# PLANNED UNIT DEVELOPMENT & SUBDIVISION STAFF REPORT

SUBDIVISION STAFF REPORT Date: July 15, 2004

**DEVELOPMENT NAME** Rochester Place Subdivision

**SUBDIVISION NAME** Rochester Place Subdivision, Revised Plat of

# SITE PLAN

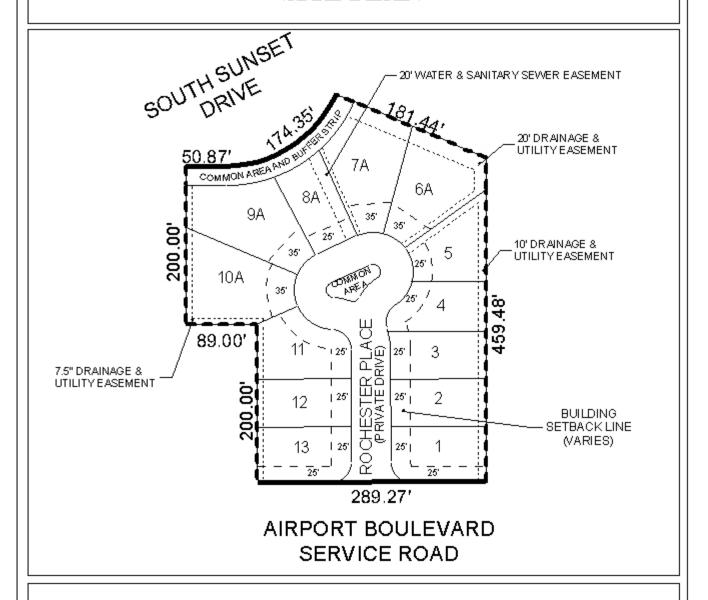
**COMMENTS** Must comply with all stormwater and flood control ordinances. Any work performed in the right of way will require a right of way permit.

**COMMENTS** Driveway number, sizes, location and design to be approved by Traffic Engineering and conform to AASHTO standards.

COMMENTS Property to be developed in compliance with state and local laws that pertain to tree preservation and protection on both city and private properties (State Act 61-929 and City Code Chapters 57 and 64). Any work on or under the 53" Live Oak Tree located along the North property line of Lot 10 A is to be permitted and coordinated with Urban Forestry; removal to be permitted only in the case of disease or impending danger.

The plat illustrates the proposed conversion of a 13-lot,  $3.4\pm$  acre subdivision to a private street subdivision. The applicant revised the approved subdivision to allow the vacation of the public street to create a 13-lot private drive subdivision.

The proposed development is not a family division of five or fewer lots, and the applicant has submitted no documentation that would justify consideration as an innovative subdivision, a gated community or that unusual difficulties exist.

There are no changes in the application, nor changes in any conditions surrounding the development or in the immediate vicinity, the staff comments from the previous application are also unchanged. Therefore, the proposed subdivision does not meet the criteria for a private road subdivision; moreover, the conditions of the previous subdivision, including the dedication and construction of the street to city standards, have been met and several homes have been constructed.

**RECOMMENDATION** Planned Unit Development: Based on the preceding, it is recommended that this application be denied.

**Subdivision:** Based on the preceding, it is recommended that the application be denied.
